**City of Delaware  
Request For Proposal – Meter Automation**

**Addendum No. 1  
August 21, 2015**

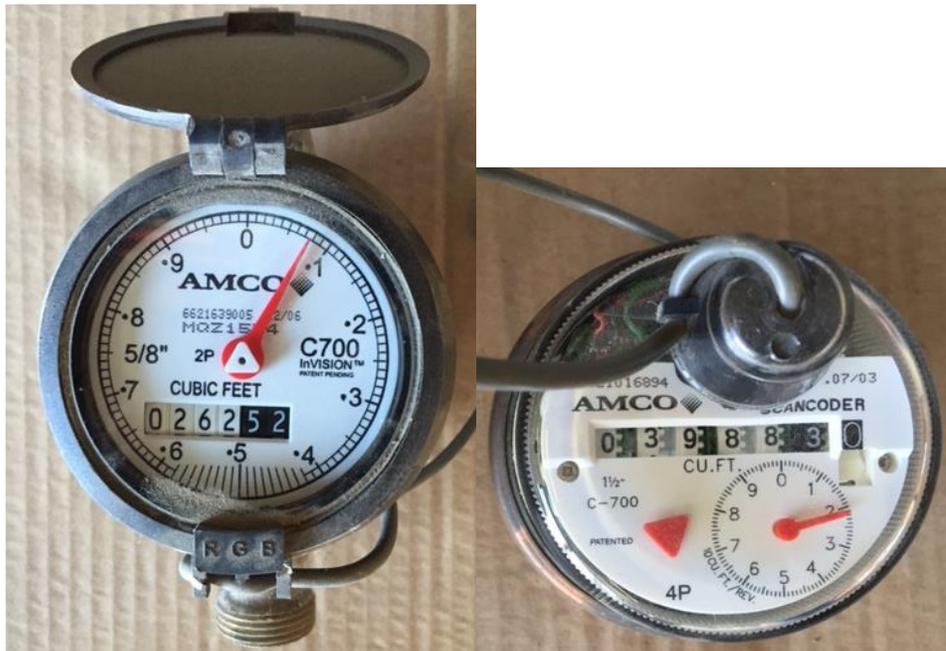
50. **The now discontinued Elster AMCO C700 register came in both a synchronous and asynchronous programming type. One is compatible with the open, AMI protocol as most meter vendors provide, the other is not. Does the City know whether the register on the C700 meters can be read by an open protocol reading system?**

Answer: The open protocol is believed to be used. Please see below for a series of photos of typical meter registers:
